1" IMPACT WRENCH

Model 6910 (MJ)

SERVICE CHANGES

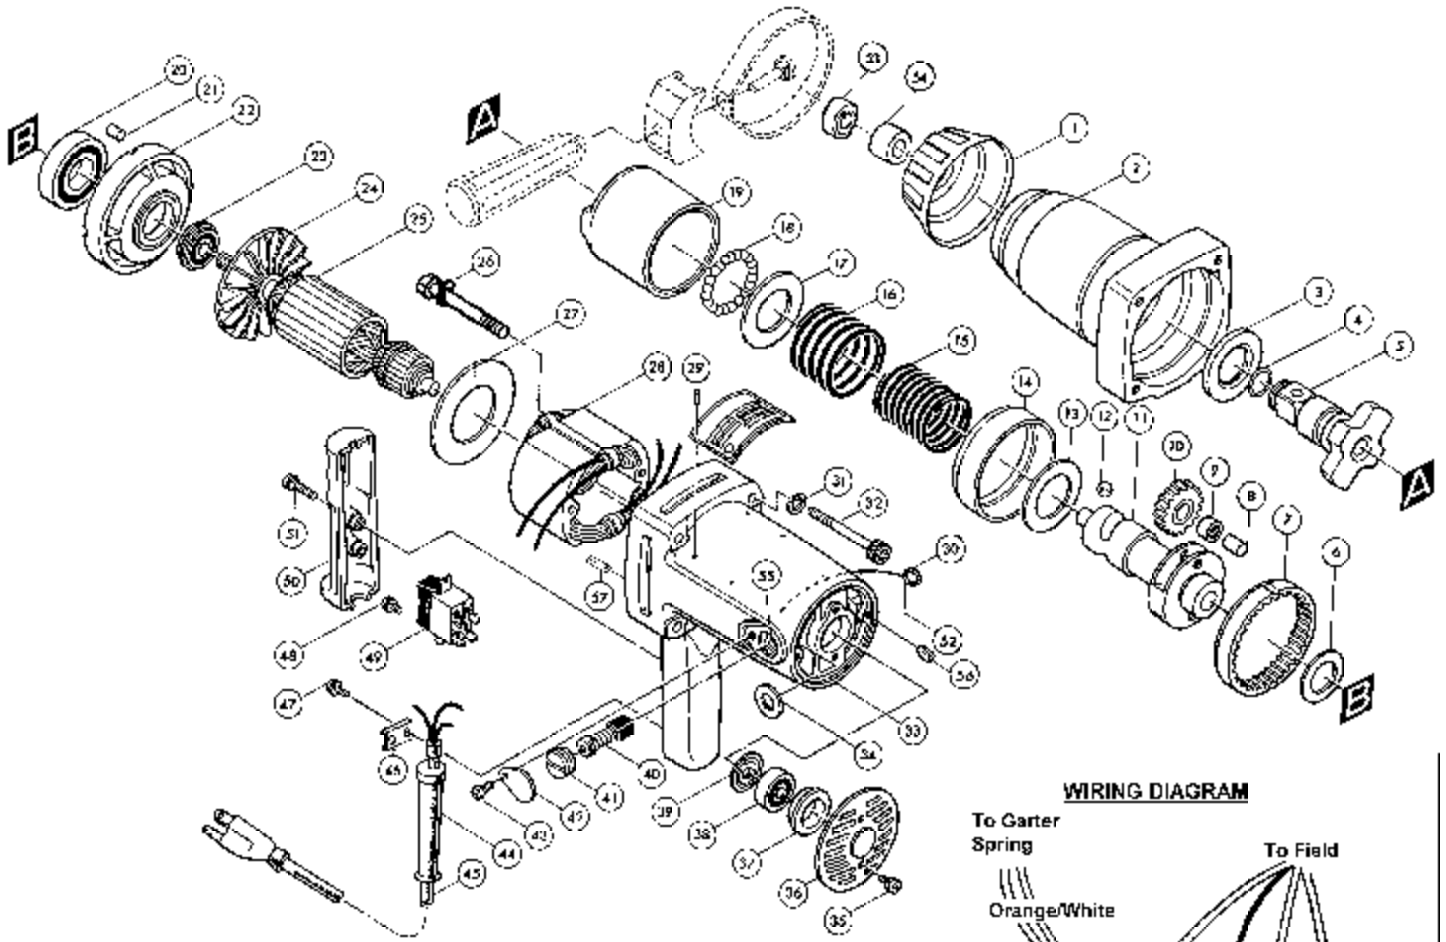
1. Change on Anvil.

Item No.	Description	Type 1	Type 2
4	Ring Spring 22	-----	231921-7 (Added)
5	Anvil	325414-5 (No Longer Available)	325587-4
60	Pin	325365-2 (No Longer Available)	(Discontinued)
61	Spring	231213-4 (No Longer Available)	(Discontinued)
62	Slotting Pin	256710-9 (No Longer Available)	(Discontinued)

Above parts are completely interchangeable as a set.

When replacing Type 1 Anvil, replace it with complete set of Type 2 parts.
